**Re: Loveland Ready-Mix Concrete, Inc., Green/Croissant Property Sand and Gravel Mine, File No. M-2001-022, Cell 4 Reclamation Slope Evaluation Review**

The Division of Reclamation, Mining and Safety (Division/DRMS) reviewed the contents of the Loveland Ready-Mix Concrete, Inc. (LRM) Cell 4 Reclamation Slope Evaluation by Telesto Solutions Inc. dated July 28, 2021 for the Green/Croissant Property Sand and Gravel Mine, File No. M-2001-022, and submits the following comments. LRM was required to submit the report to comply with a problem cited by the Division following the May 20, 2021 inspection.

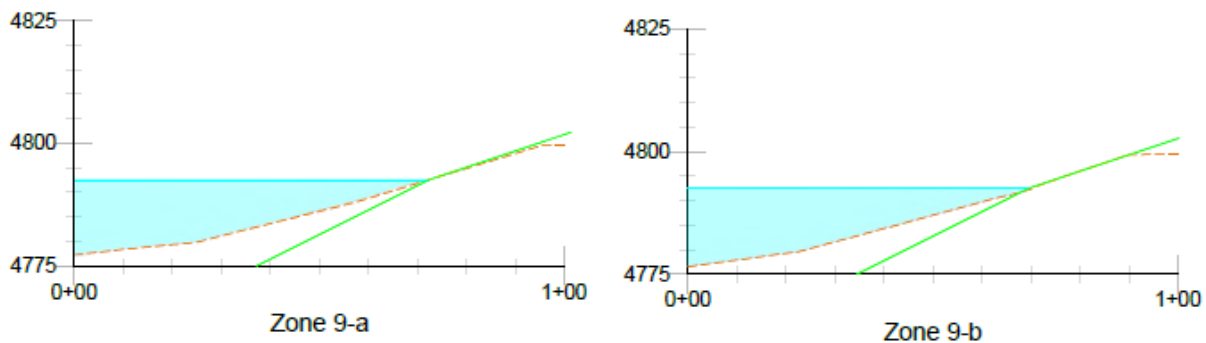
1. On page 3 of the report, the report states, Sheet 1 shows the results of the 38 cross sections evaluated and all show compliance with Rule 3.1.5(7). The Telesto evaluation presents the slopes below the waterline are acceptable at a 2H:1V grade. The Telesto evaluation is incorrect since the Rule requires slopes of 3H:1V ten (10) feet below the expected waterline, not at the waterline. Additionally, the 2H:1V slopes below the waterline are not in compliance with the approved Reclamation Plan, which requires slopes of 3H:1V from the top of the bank to the pit floor.

6. For Zones 9, 20, 25, 26 and part of 27 the report states the following:
  - a. Zone 9: Both sections (Zone 9a and Zone 9b) show slopes at or shallower than 3H:1V for 15 feet horizontally from water’s edge, and flatter below the water surface.

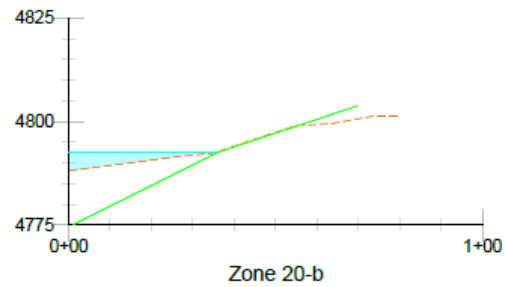
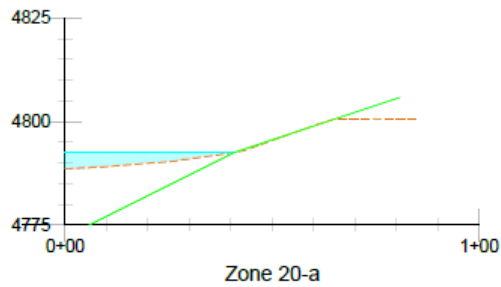
The Division agrees the slope appears to be 3H:1V and in compliance above the waterline. The Division does not agree the slope below the waterline complies with the requirements of the approved Reclamation Plan. Please explain the comment that the slopes below the waterline are flatter.

- b. Zone 20: Both sections (Zone 20a and 20b) show slope compliance because the average slopes 15 feet and 20 feet horizontally from water’s edge (above and below water level, respectively) are shallower than Rule 3.1.5(7) requirements.

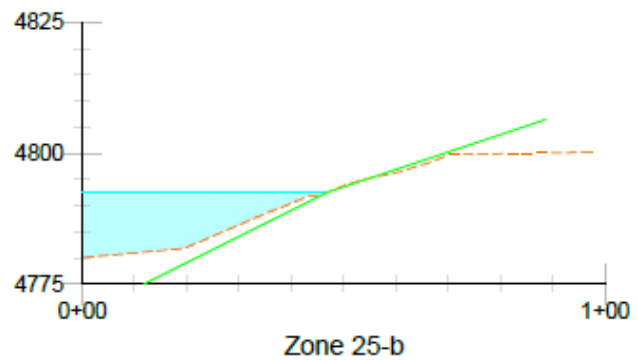
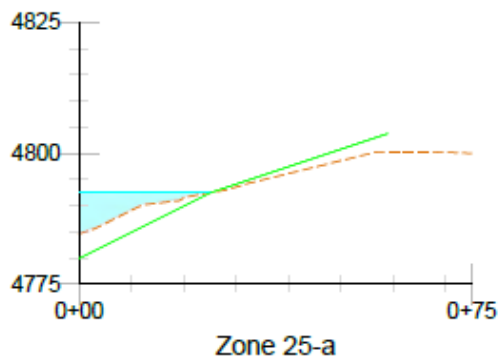
The Division agrees the slope appears to be 3H:1V and in compliance above the waterline. The Division does not agree the slope below the waterline complies with the requirements of the approved Reclamation Plan.

- c. Zone 25: Section Zone 25a is shallower than the Rule requirement. Section Zone 25b averages 3H:1V for 15 feet from the water's edge

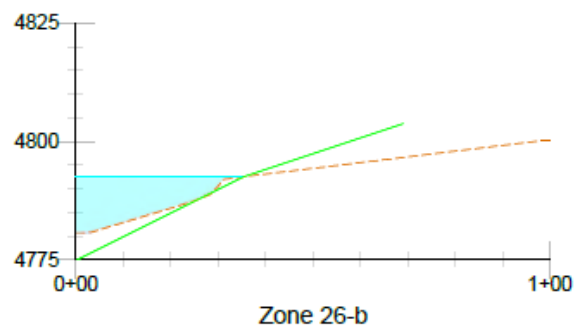
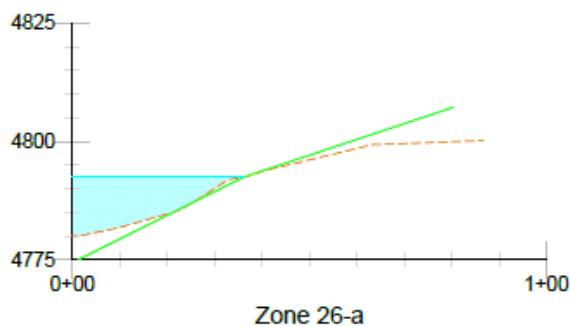
The Division agrees the slope appears to be 3H:1V and in compliance above the waterline. The Division does not agree the slope below the waterline complies with the requirements of the approved Reclamation Plan.

- d. Zone 26: Above the water level, both sections show the slopes are gentler than Rule requirements. Below the water level, the average slopes are at the requirement.

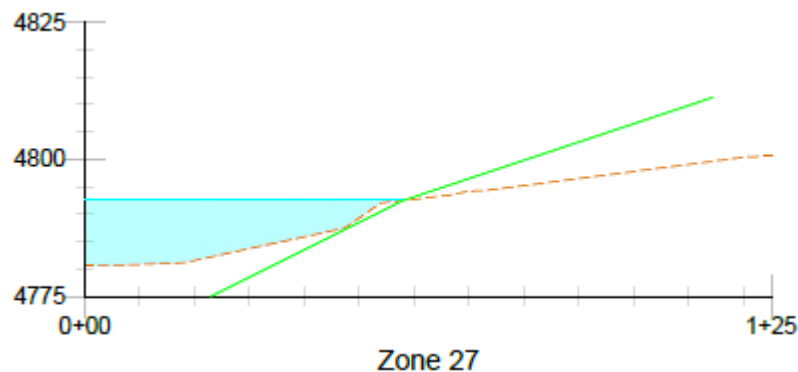
The Division agrees the slope appears to be 3H:1V and in compliance above the waterline with the exception of the typical shoreline erosion area. The Division does not agree the slope below the waterline complies with the requirements of the approved Reclamation Plan.

## Sheet 1

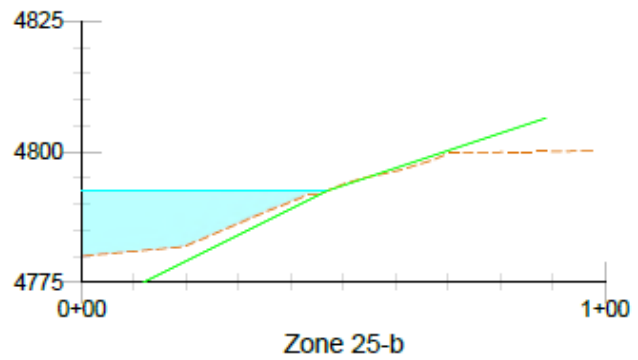
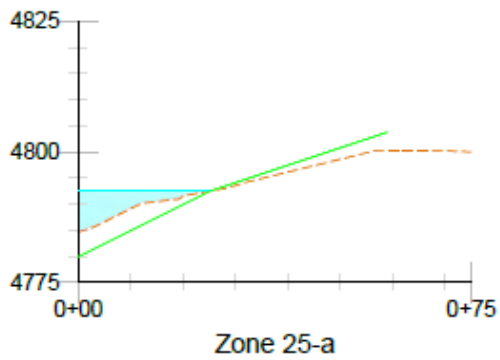
9. The cross sections for Zone 25 on Sheet 1 and Sheet 2 are different. Please explain this discrepancy and revise the maps accordingly.
